{ Denotes changes to ADD. 98 - 10/15/76 CO ADD. 98 - 5/5/77

H-1 VIADUCT (WB)

INDEX TO DRAWINGS
ESTIMATED QUANTITIES

KEEHI INTERCHANGE
F.A.I. PROJ. NO. I-HI-1 (130): 17

**TEMPORARY RAMPS
LAYOUT PLAN AND
LONGITUDINAL SECTION**

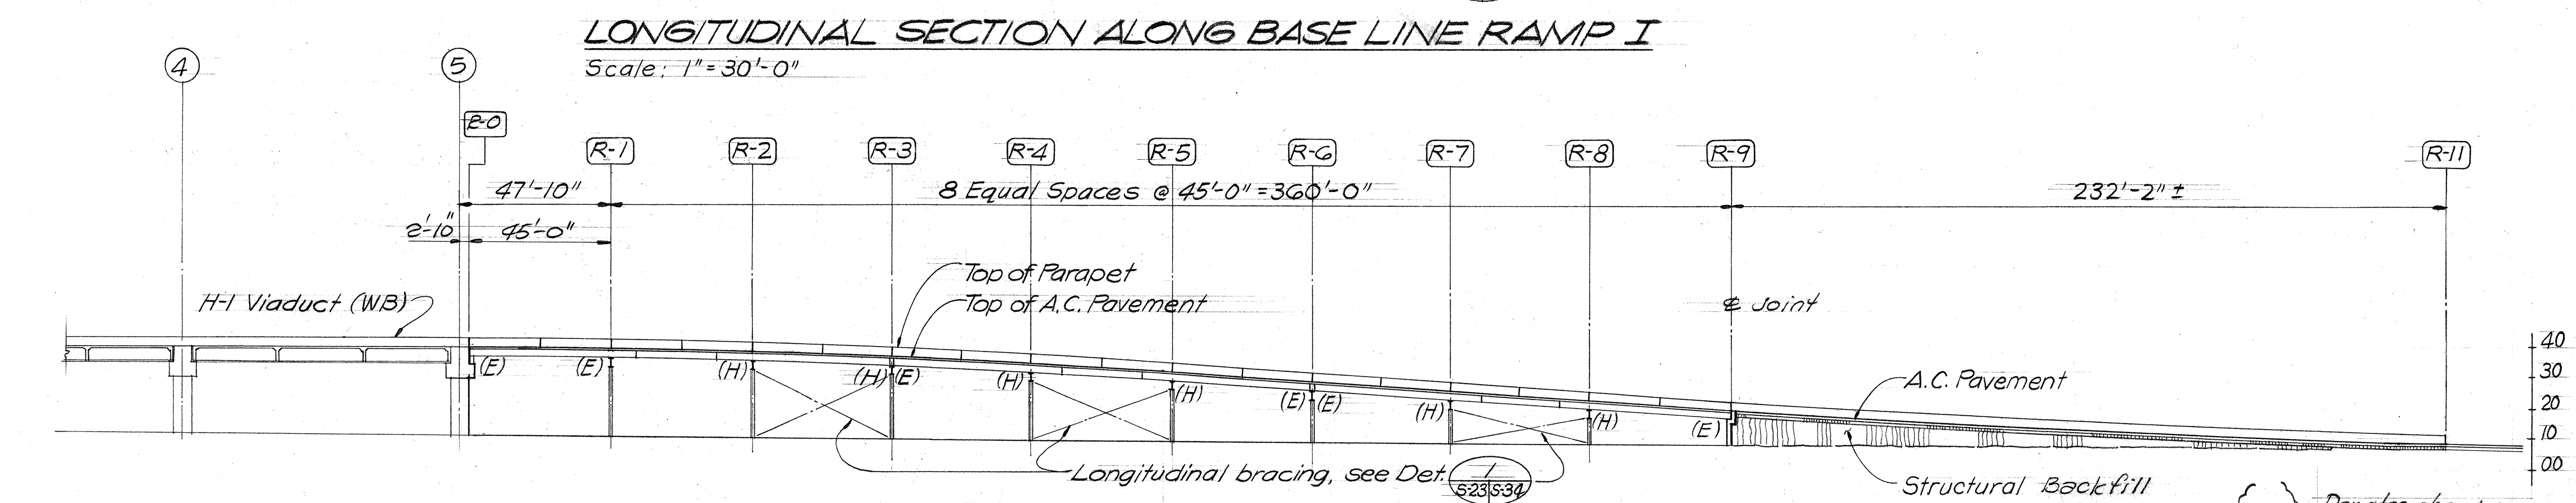
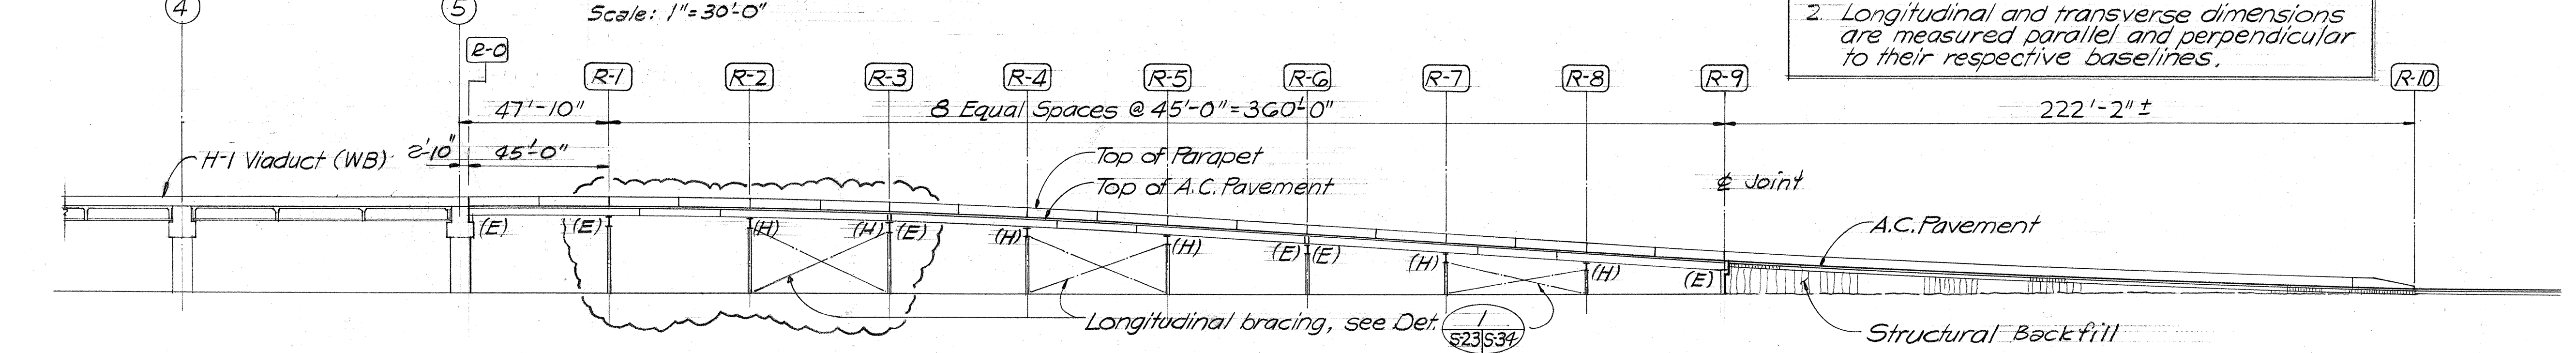
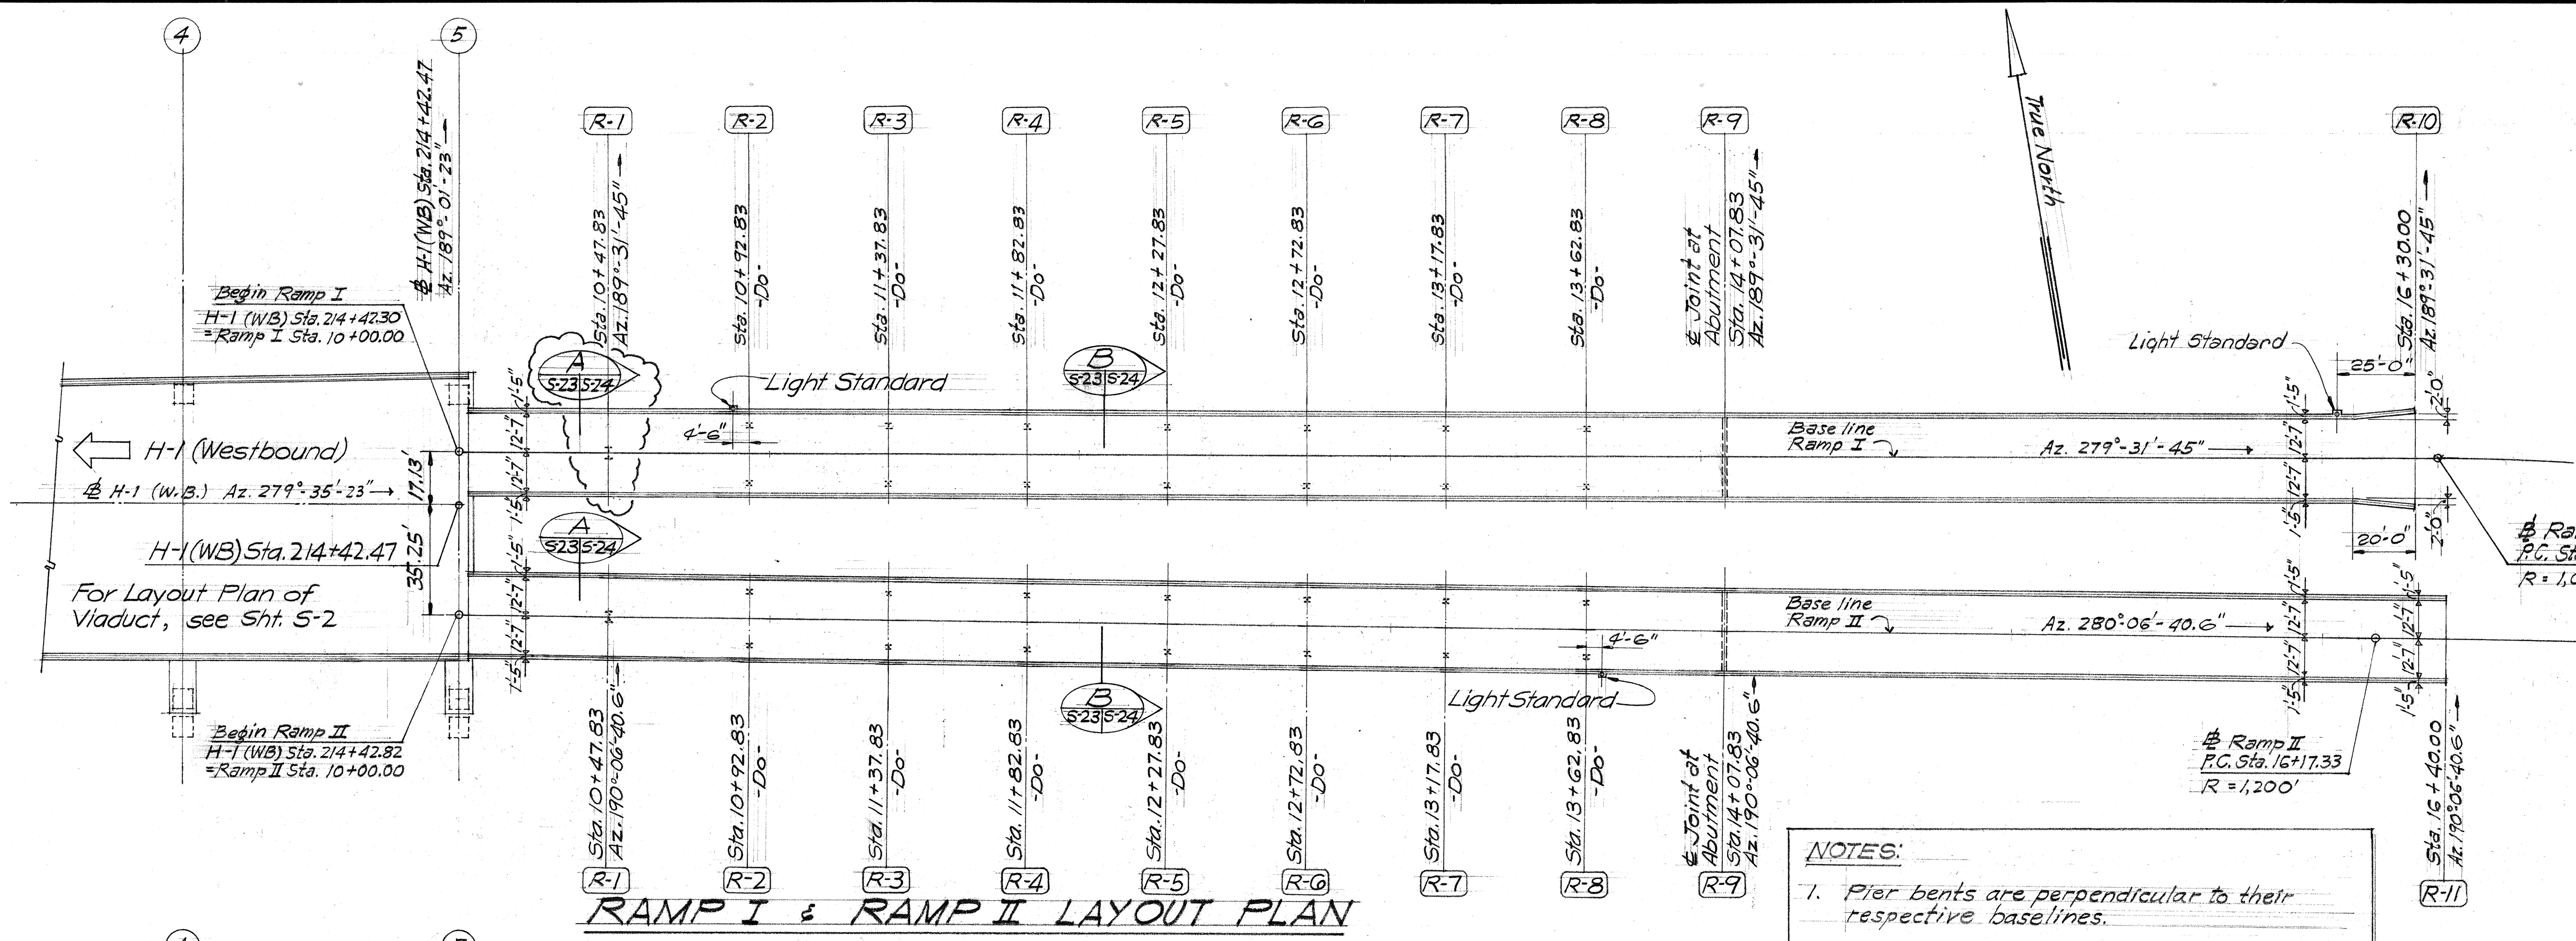
DATE	REVISION
10/15/76	Revised to single col. pier bent at Ramp I (R-1) & moved Longitudinal Bracing.

DECK PLAN WITH FINISH DECK ELEVATIONS (TOP OF A.C. PAVEMENT)
Scale: 1" = 30'-0"

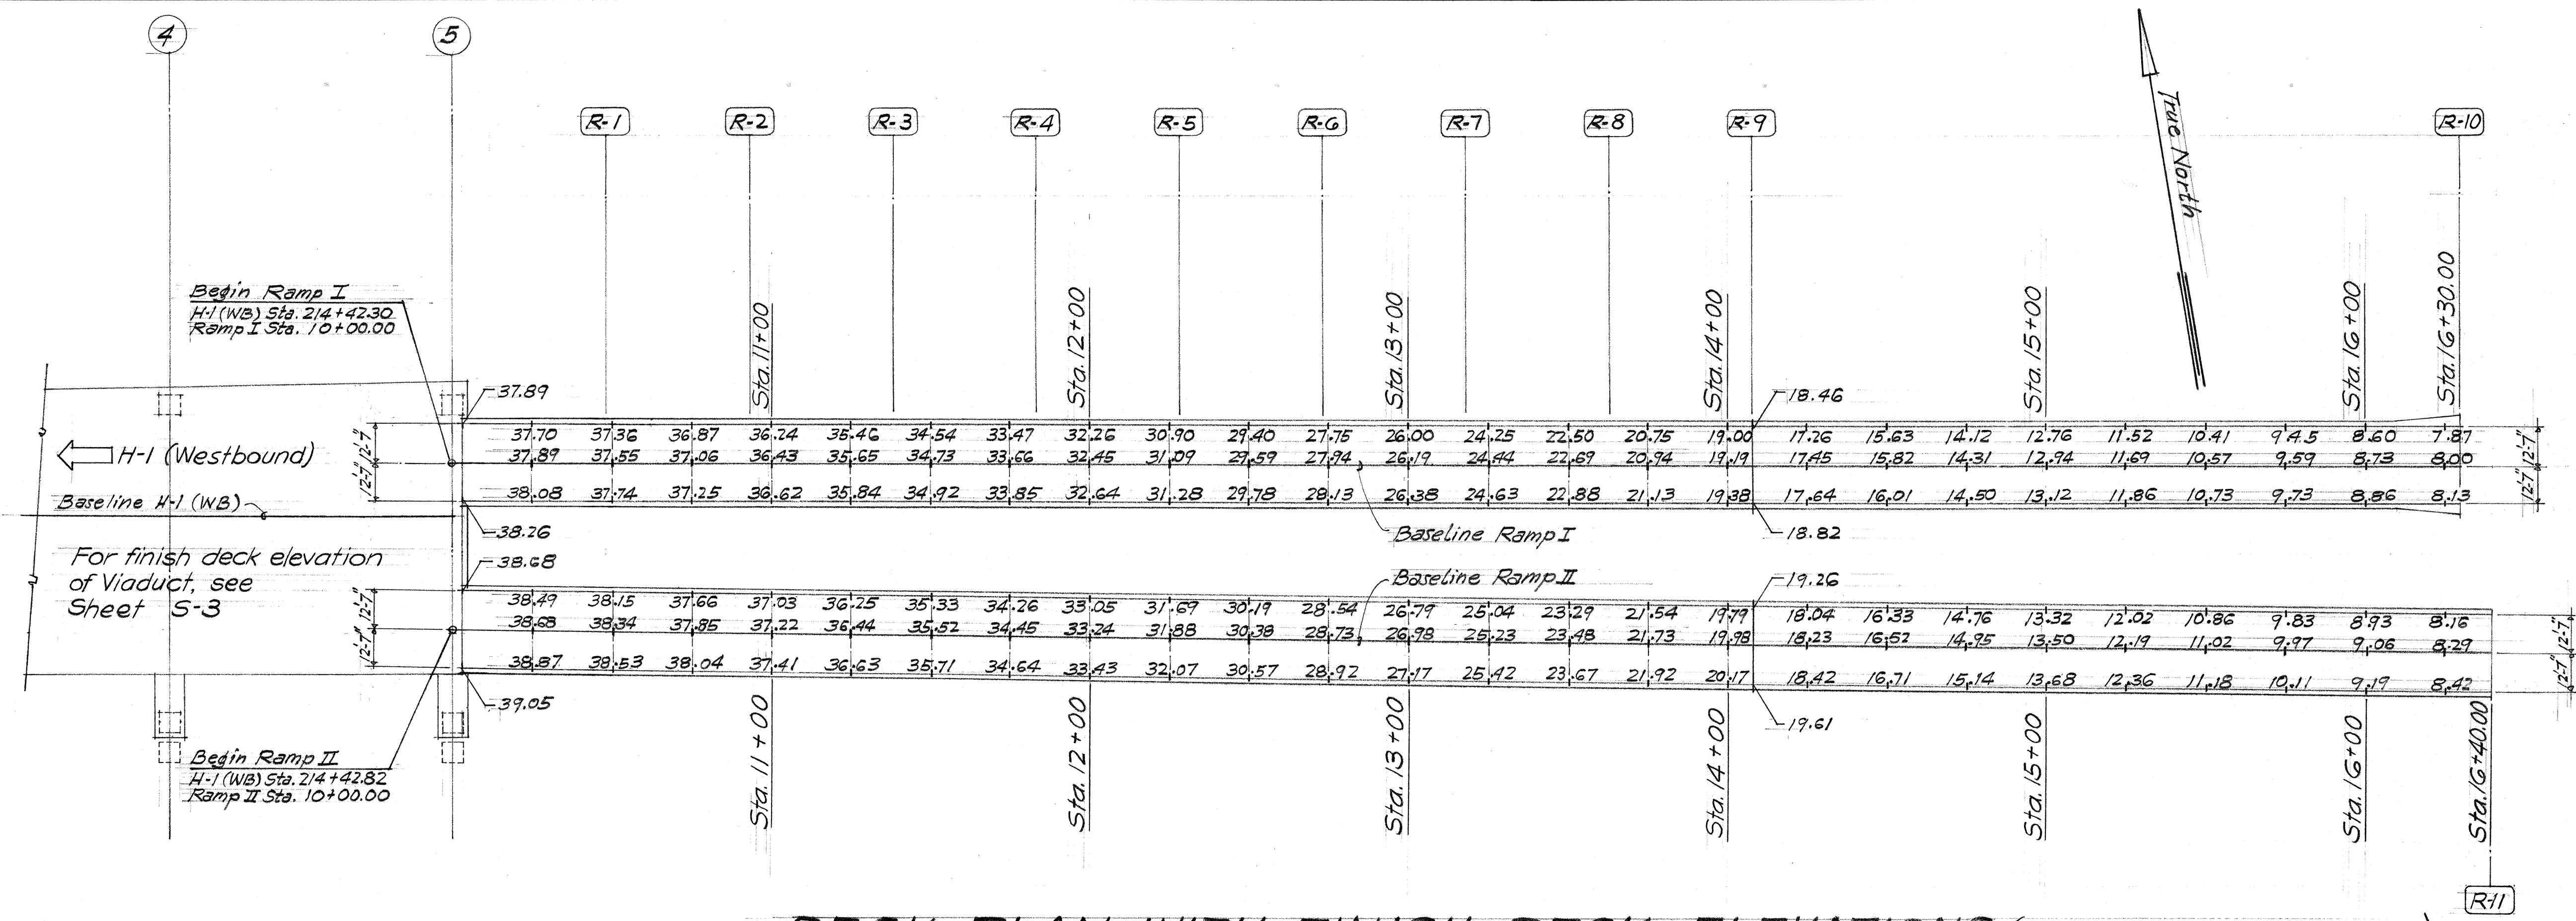
DATE	REVISION
10/15/76	Revised to single column pier bent at Ramp I, R.I. Deleted Notes on Quantities.

FOUNDATION PLAN

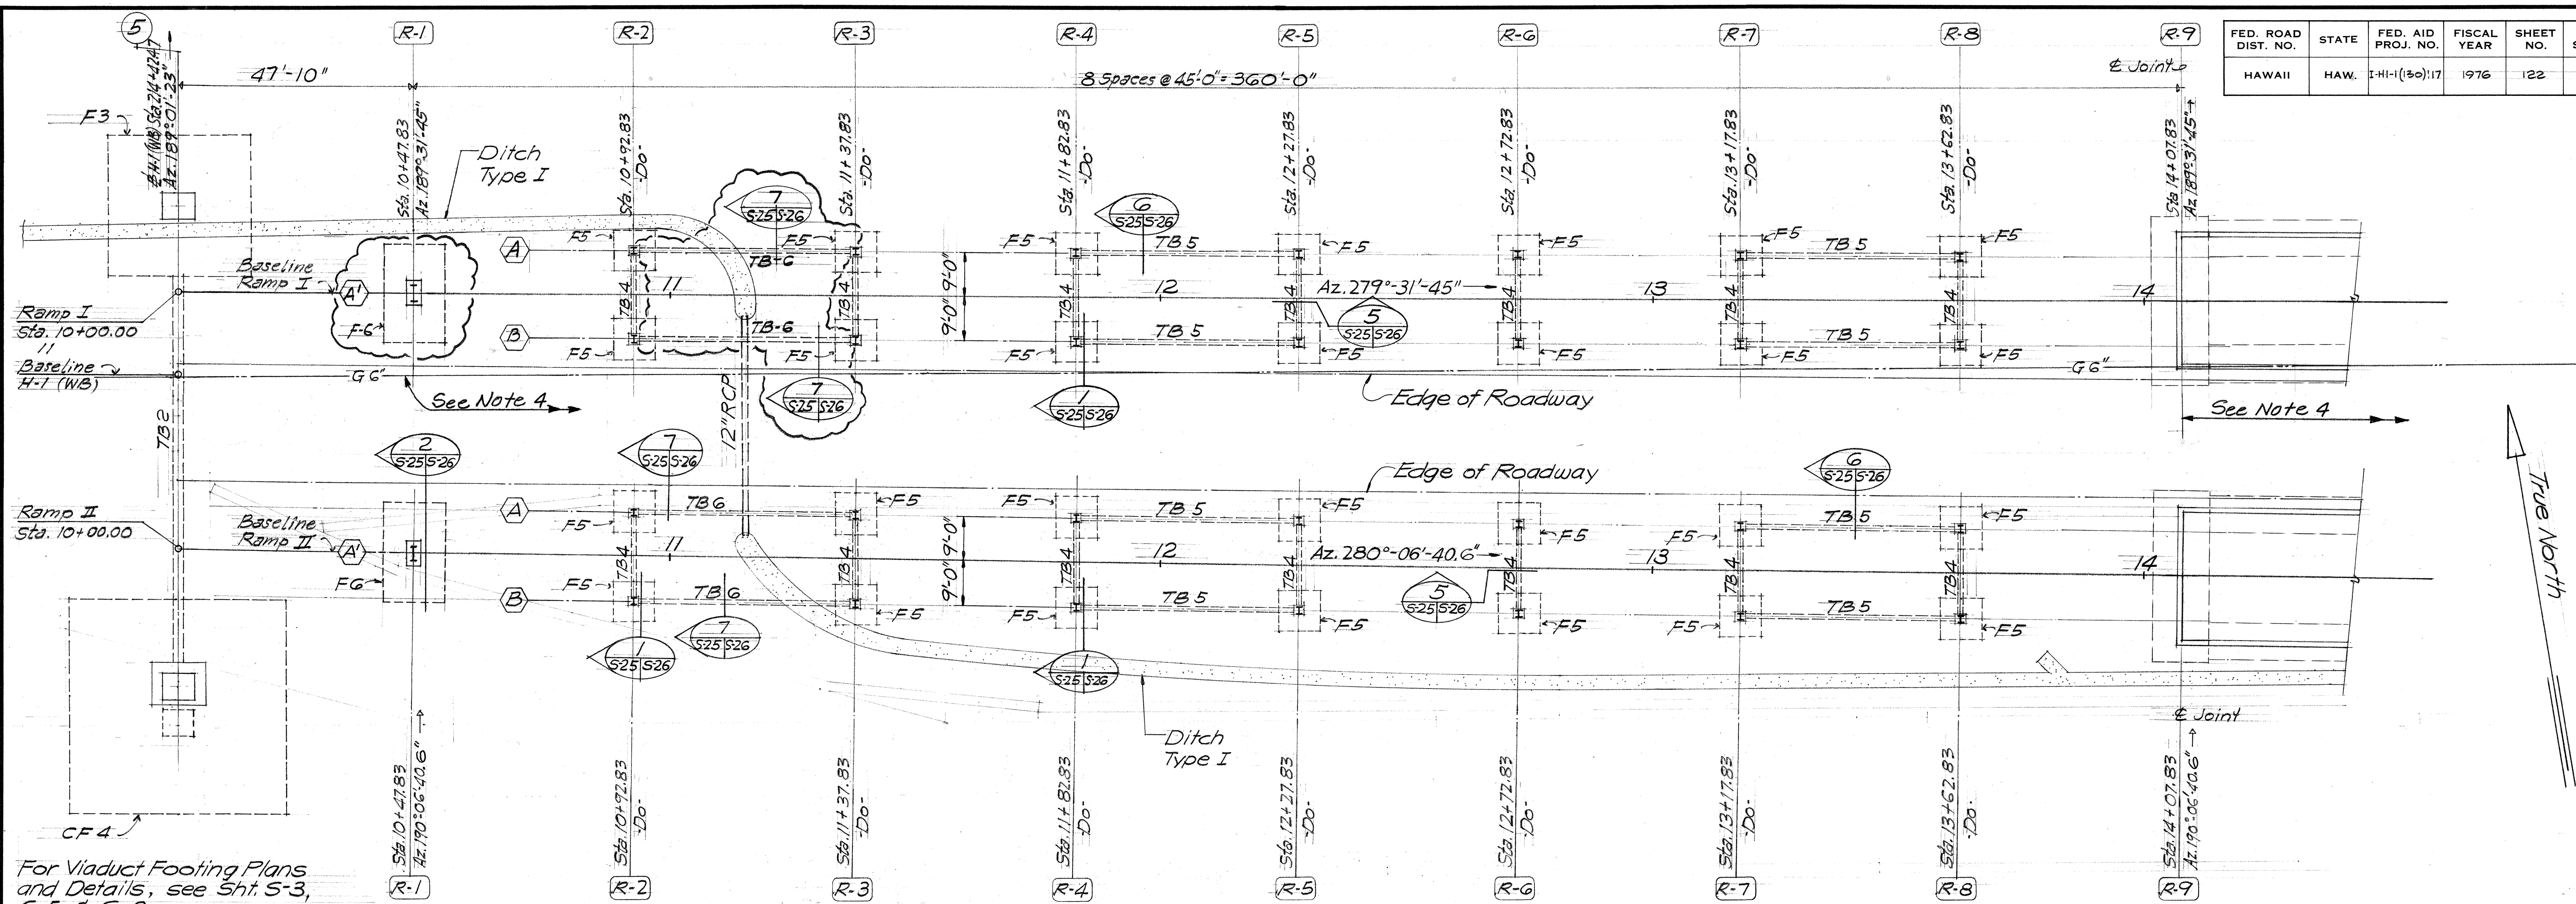
10/15/76	Revised footing and tie beams at Ramp I between R-1 & R-3.
DATE	REVISION
